ADDENDUM NUMBER 1

**Professional Development Center
and Kitchen**

For
SAN BERNARDINO CITY UNIFIED SCHOOL DISTRICT
Bid No F16-05

December 28, 2015

SITE PLAN

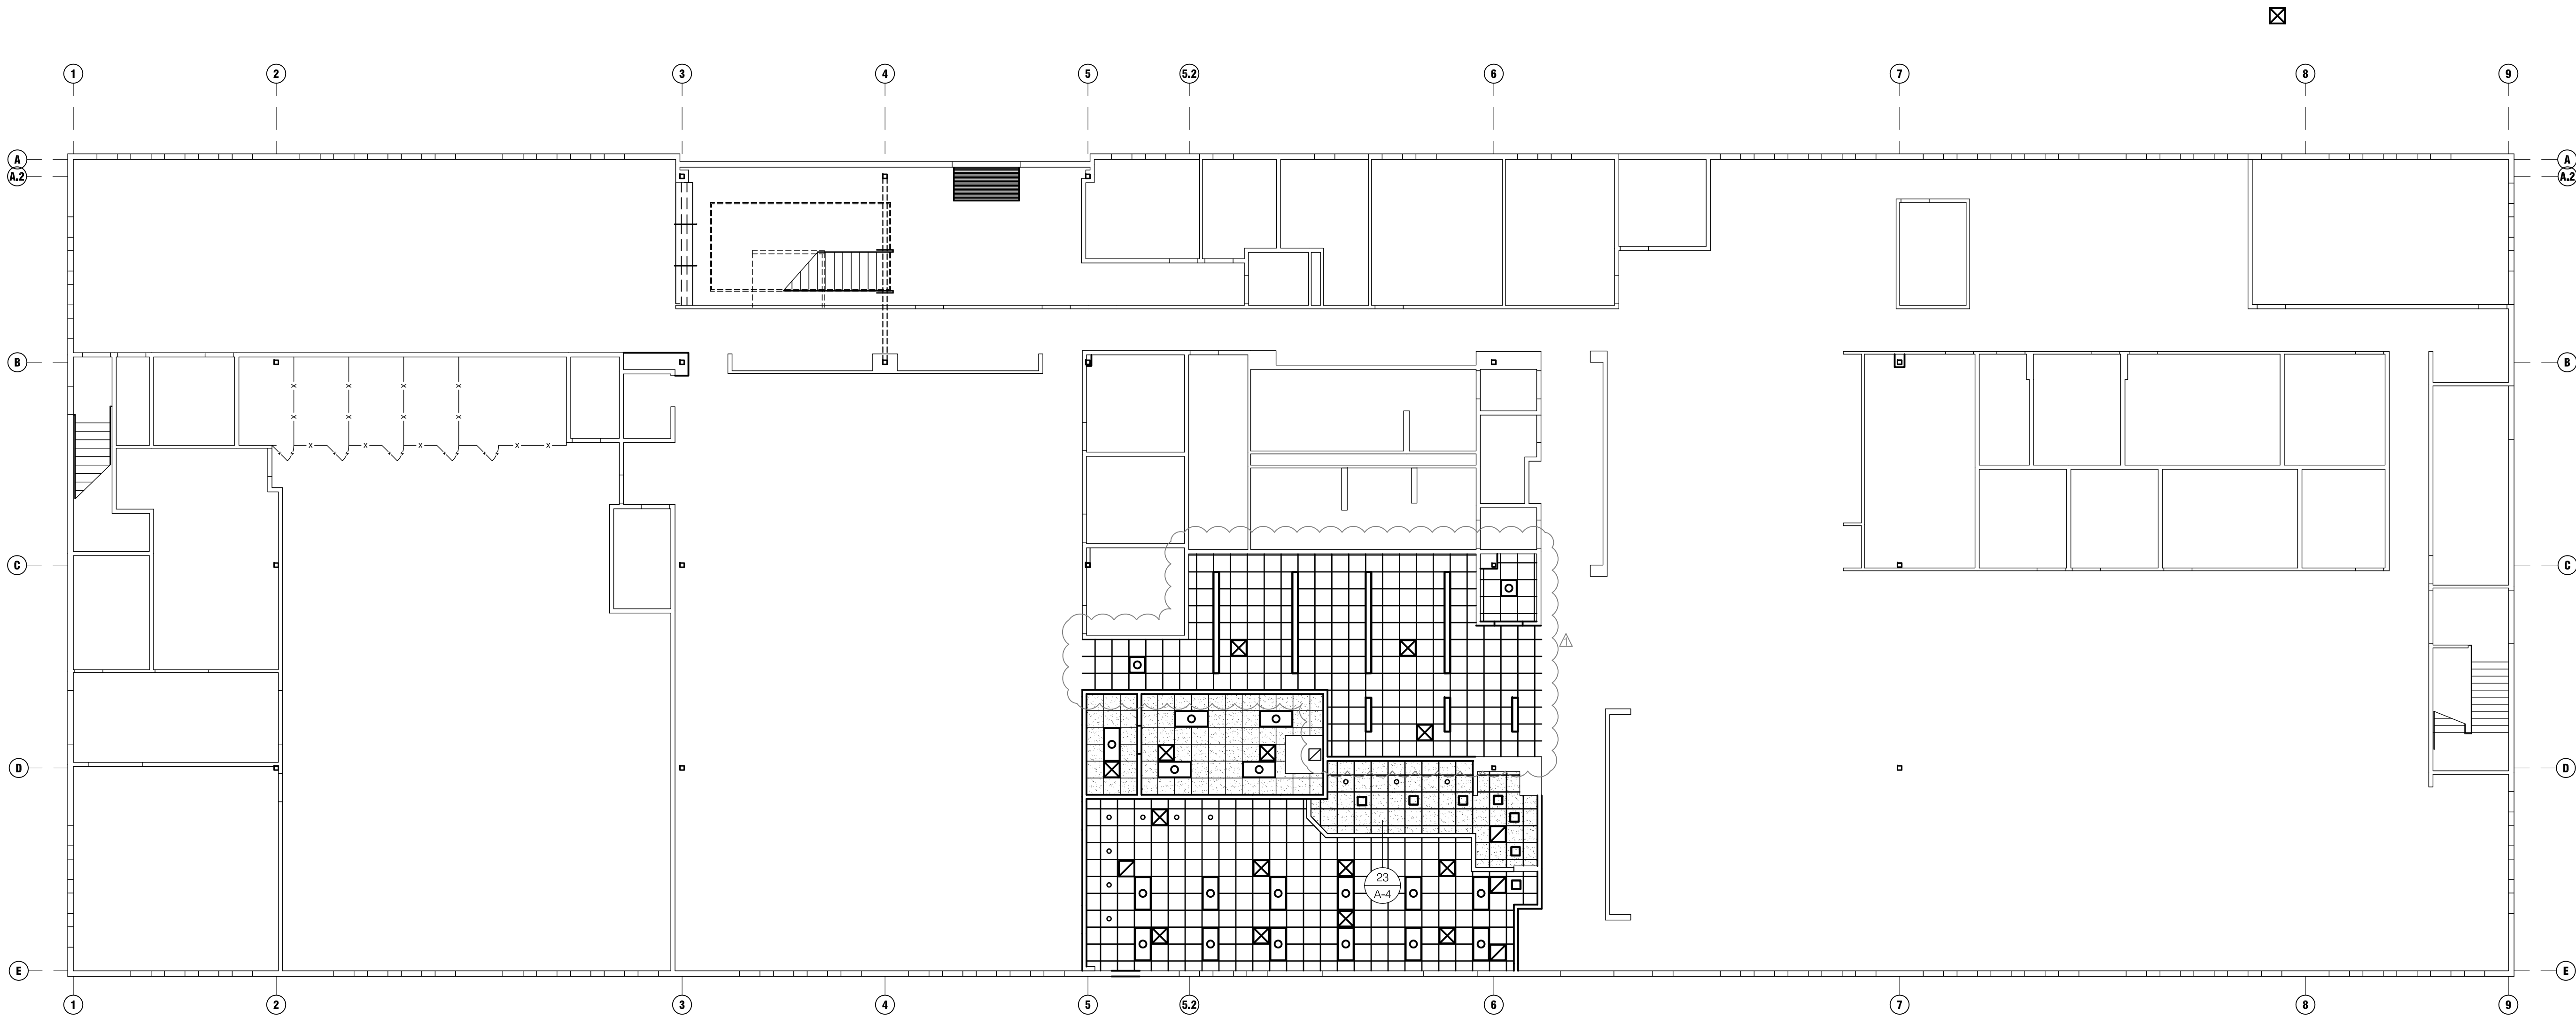
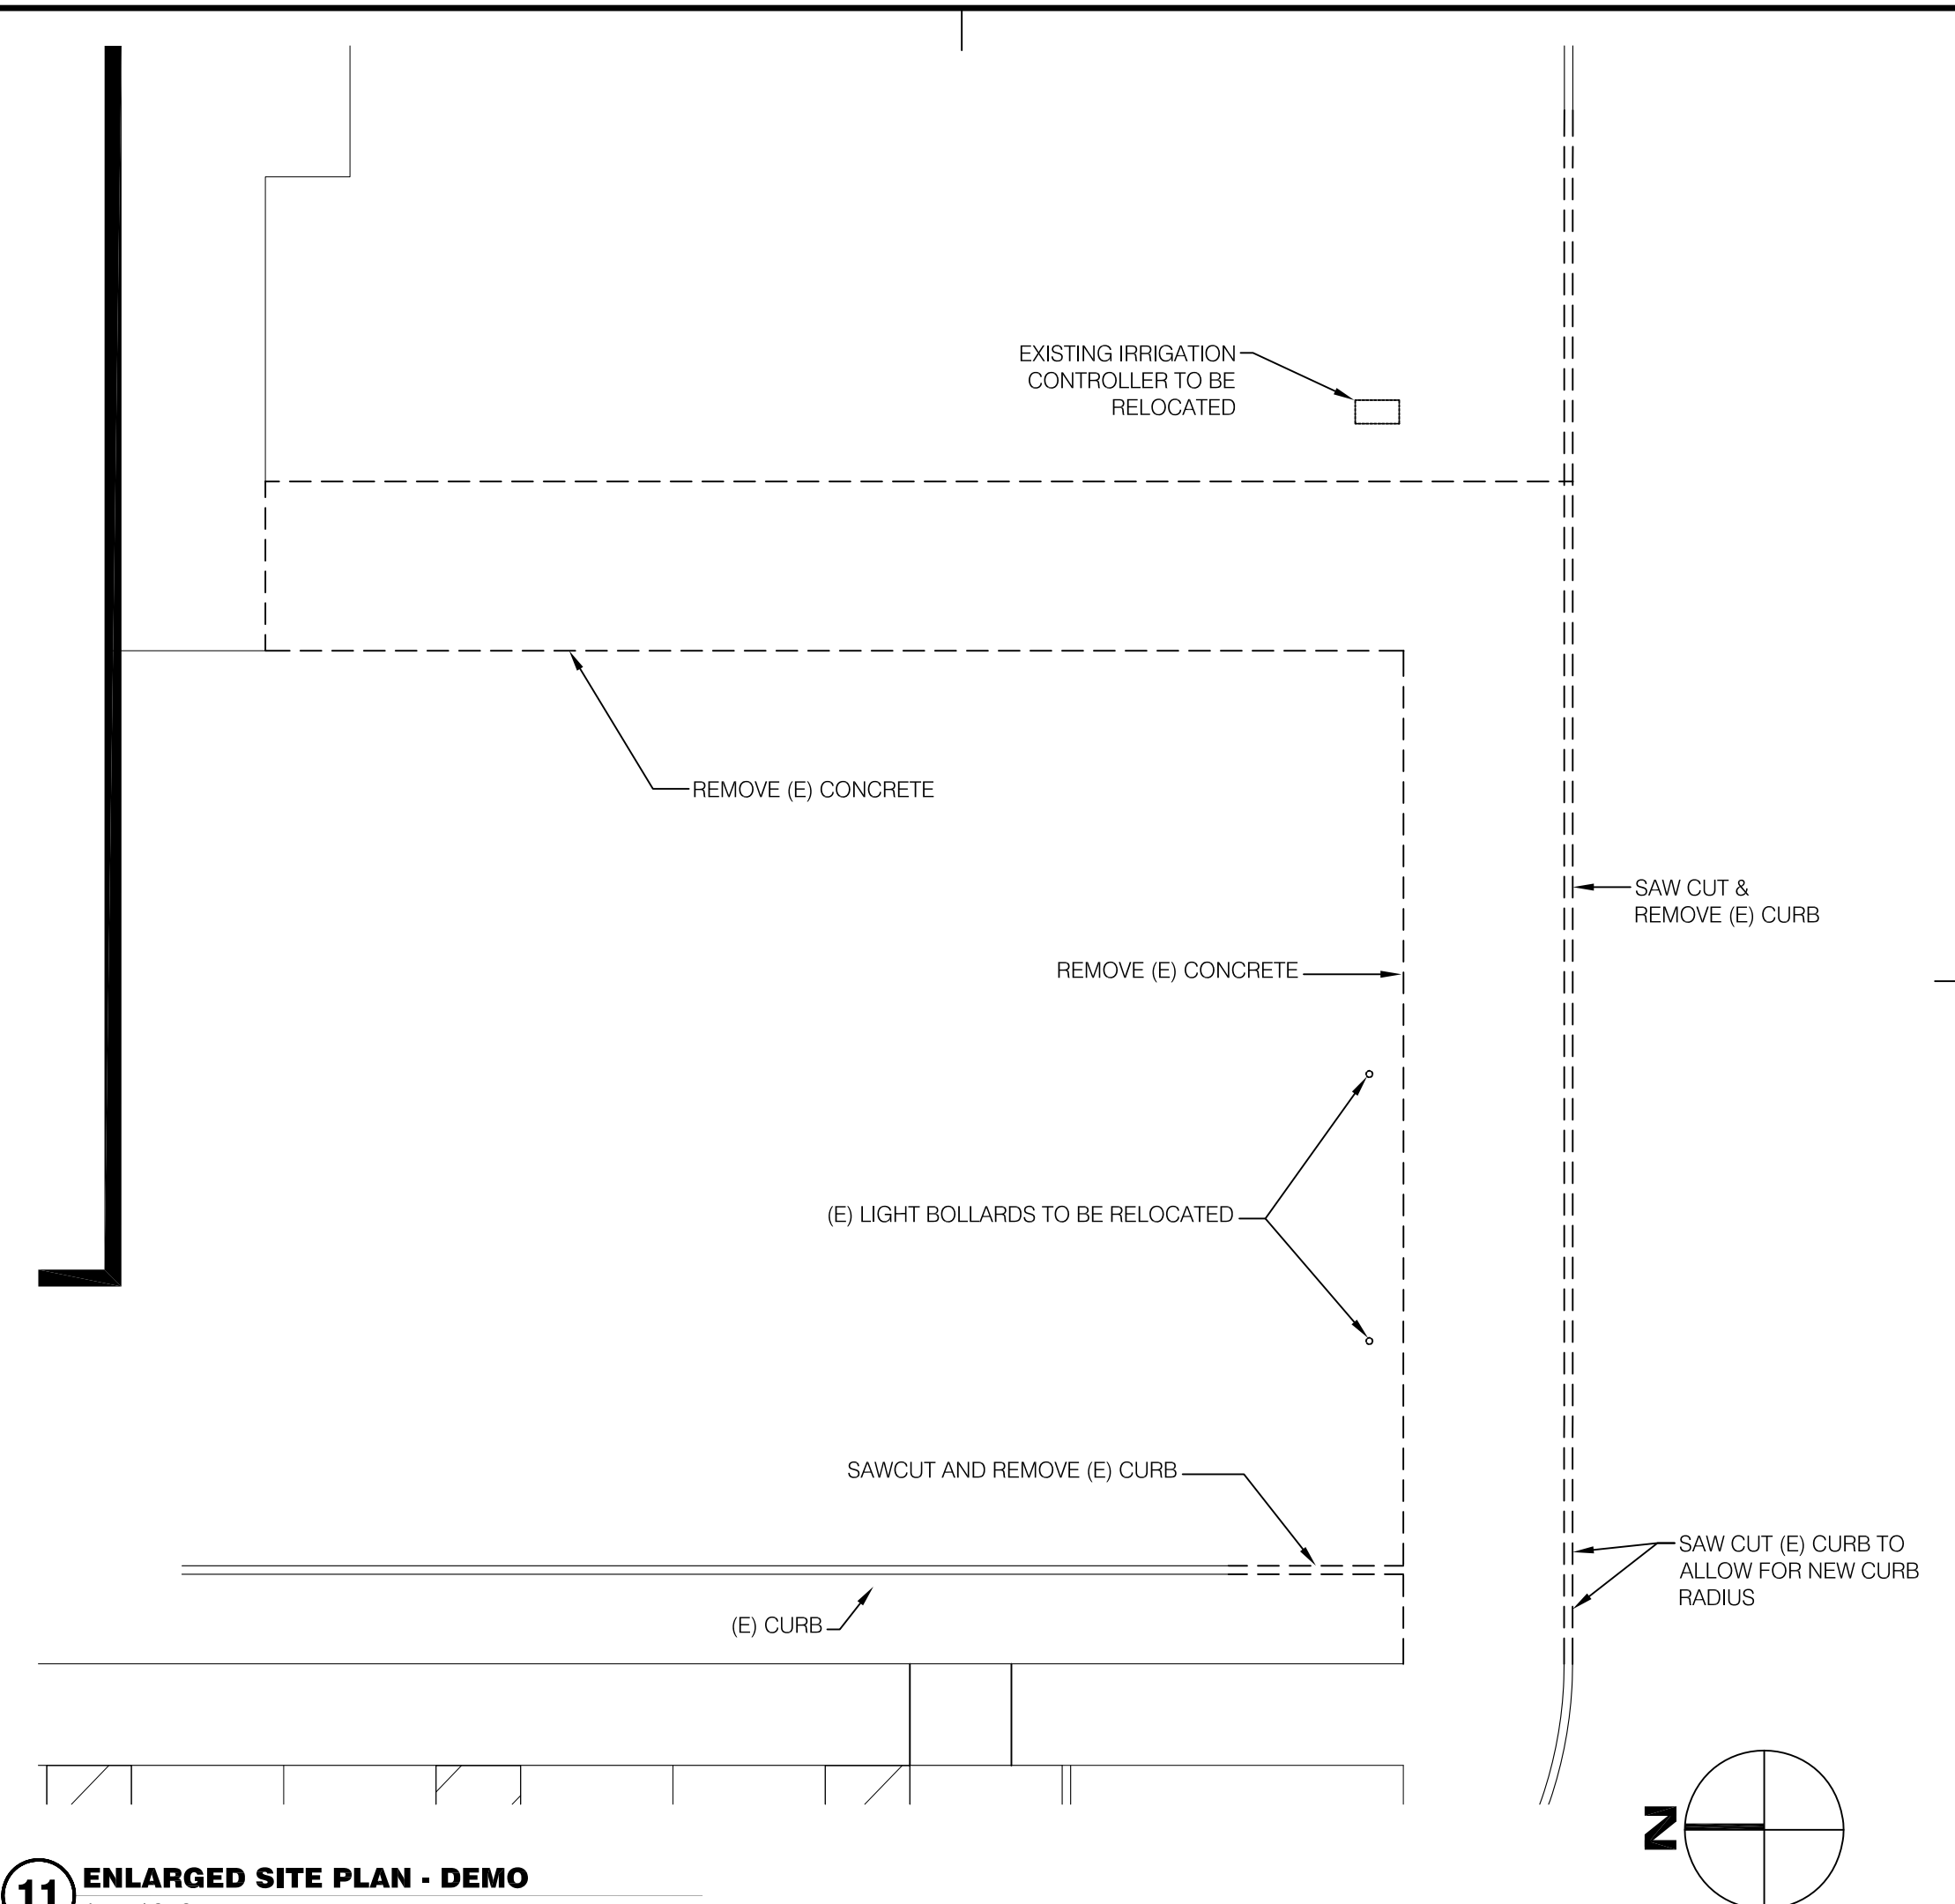
Item Number 19; Reference: Sheet A-1, Site Plan; Replace this sheet with attached sheet **A-1, Site Plan,**

Note: Revised sheet provides clarification on parking expansion, car charging stations and associated site modifications and adds details 4,10,11,16, 22,23, 25,26 and 27.
